City of San Diego

CONTRACTOR'S NAME: James W. Fowler Co.

MONTEZUMA PPL/MID-CITY PIPELINE PH2 AND 70TH-ALVARADO TO SARANAC-SIDEWALK

BID NO.: K-19-1821-DBB-3
SAP NO. (WBS/IO/CC): S-11026, B-17065
CLIENT DEPARTMENT: 2000, 2116
COUNCIL DISTRICT: 7, 9
PROJECT TYPE: KA, IK

CONTRACTOR INSPECTOR DATE STARTED DATE COMPLETED
37333-70-D

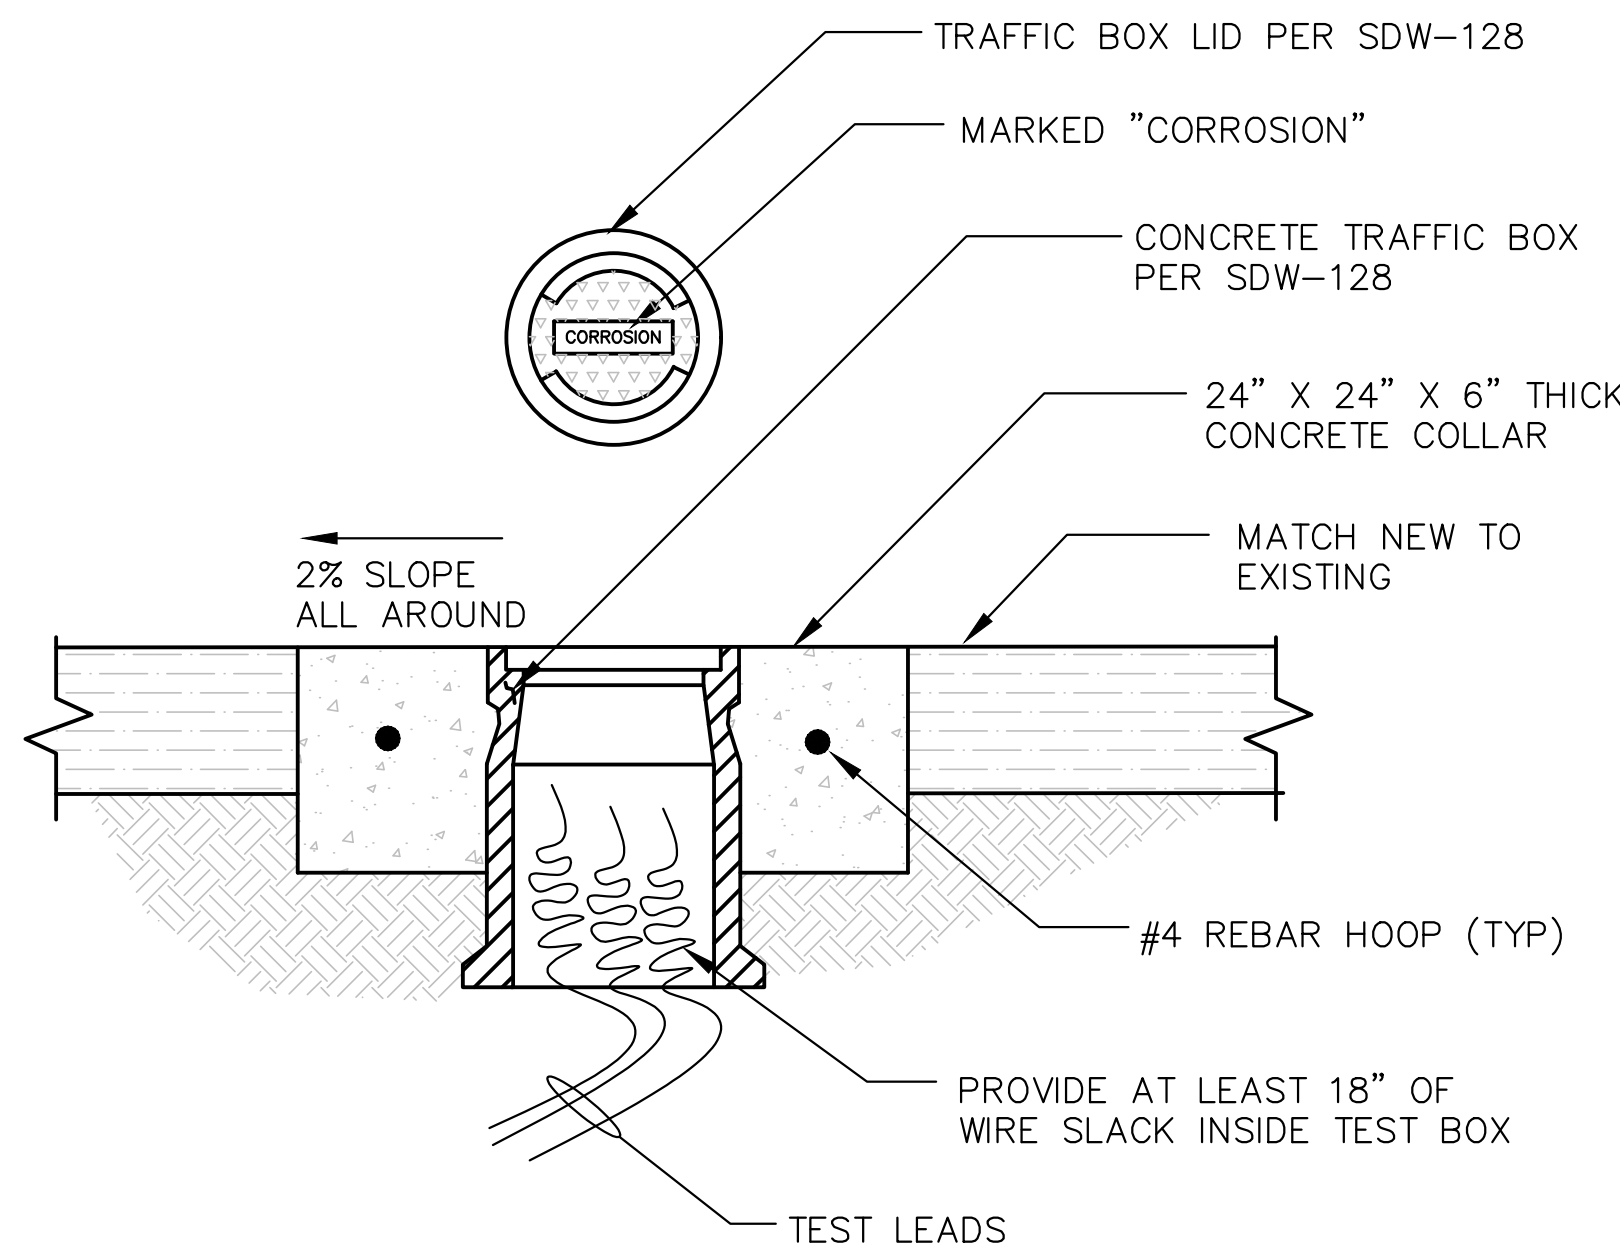
REVISED SHEET - ADDED NOTE
